Inspection of aileron weight and aileron c.g. and inspection of play (backlash) in aileron and flap control circuits to avoid flutter risk.

Glider model ASW 20, s/n 20 001 thru 20077 and 20 086.

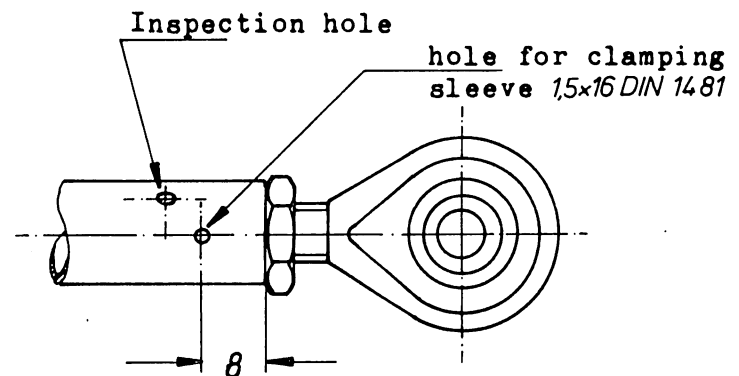
- a/ If new hollow tubular rivets including tools are available, the tubular rivet is drilled off.
  - b/ If procedure a/ is impossible, the fairing of the aileron actuator is split off carefully and the whole metal fittings are unscrewed from the ailerons.

The weight of each aileron is determined (don't forget the fairing which is split off) and compared to the tolerances given in the Manuals. If according to procedure b/ the metal fittings were removed, 0.07 kg must be added to the determined weight.

Determination of tailheavy moment of controls by balancing  
on a cutting edge done twice (triangular strip)

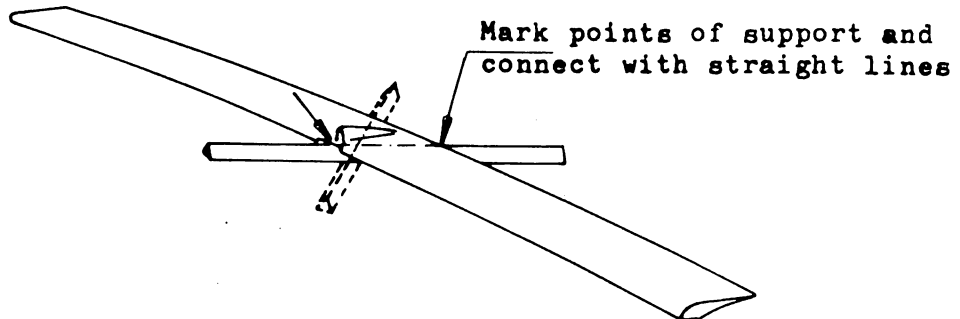
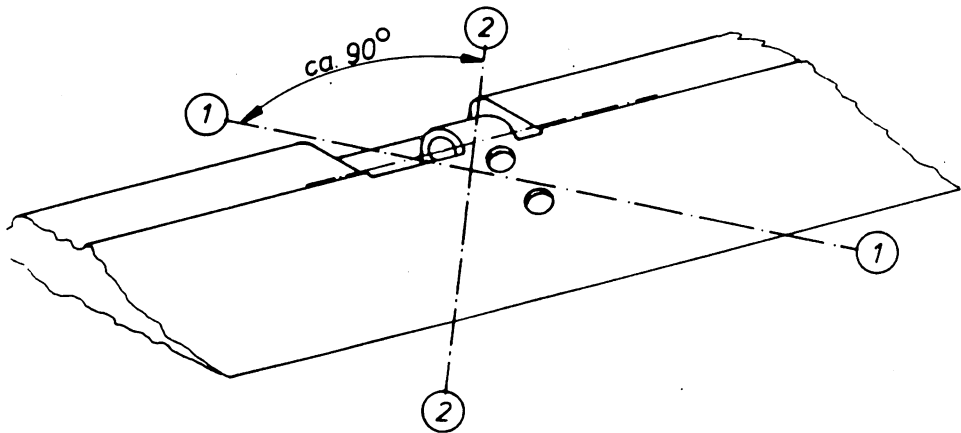
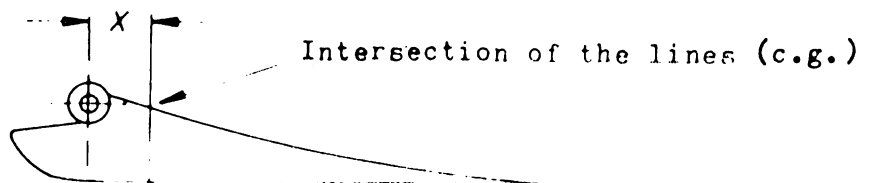
Diverging from the sketch in the Manuals the c.g. of the ailerons is balanced according to the sketch on sheet 5 of this Technical Note. The weight of the aileron (if fittings have been removed, without their 0.07 kg) as determined multiplied by the distance from the c.g. to the hingeline is the tailheavy moment of the aileron. If the actuator fitting was removed, 0.15cmkg must be added. This total moment must not be greater than tolerated by the Manuals.

The measuring method given herein is somewhat more accurate than the one given in the Manuals and also somewhat to the safe side, as the upper surface of the ailerons is not level during balancing.

The connecting lines of the points of support ① - ① and ② - ② intersect in the c.g.

X = Distance from the c.g. to the center of the hingeline.

Weight (kg) · X (cm) = Moment (cmkg)
